Date: 7 March 2025

Project No. 416.065599.00001

RE: Land at Roundwood Back Lane, Graveley, SG1 6GJ
Response to LLFA Consultation Comments on Surface Water Drainage

SKETCH 1

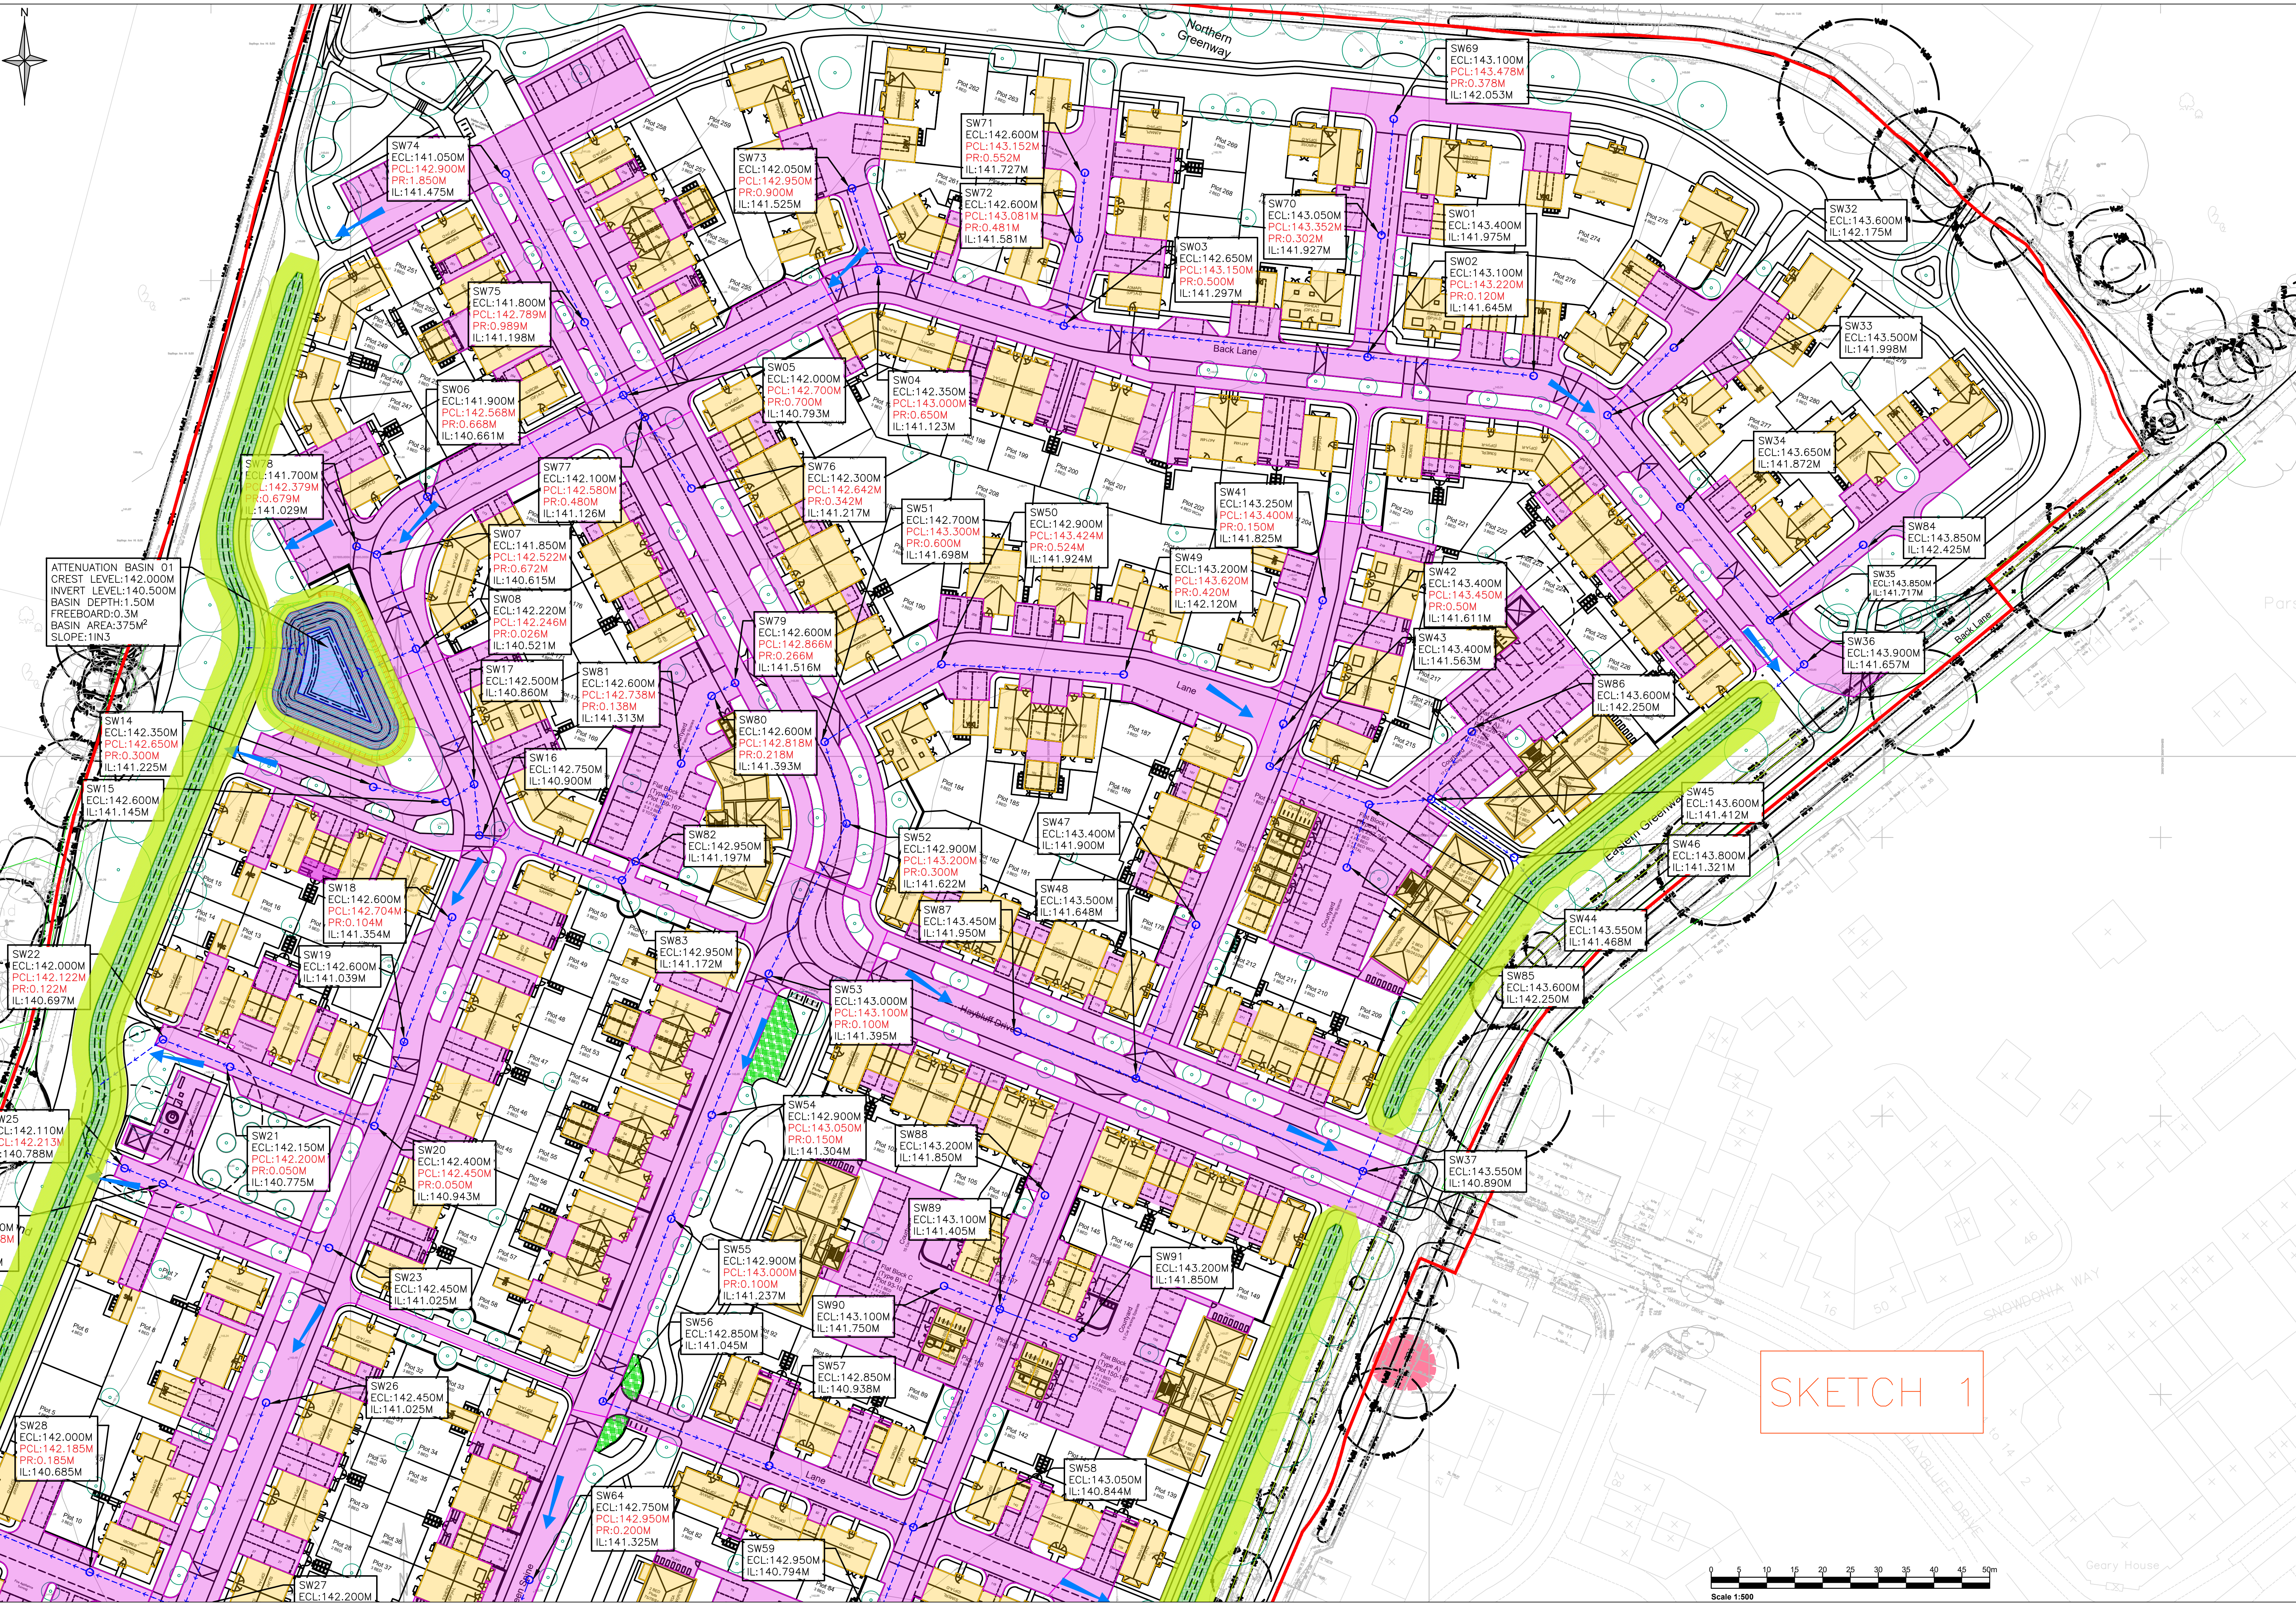
Appropriate easements (to the adopting authority standard) to SuDS features (Ponds and Swales) should be shown on a drawing, this will be a minimum of 3m.

I have enclosed two sketches which show a 3m wider buffer from the edge of the swale and ponds. You'll note that a 3m wide area is available around the swales but includes footpaths and hedges in places.

Access to the ponds for maintenance purposes will also be required on foot. A minimum 1m wide grassed verge was incorporated around each pond with additional space for footpaths and a cycle path. These features can offer dual functionality. The enclosed sketches show the availability of a 3m wide area for maintenance access provision.
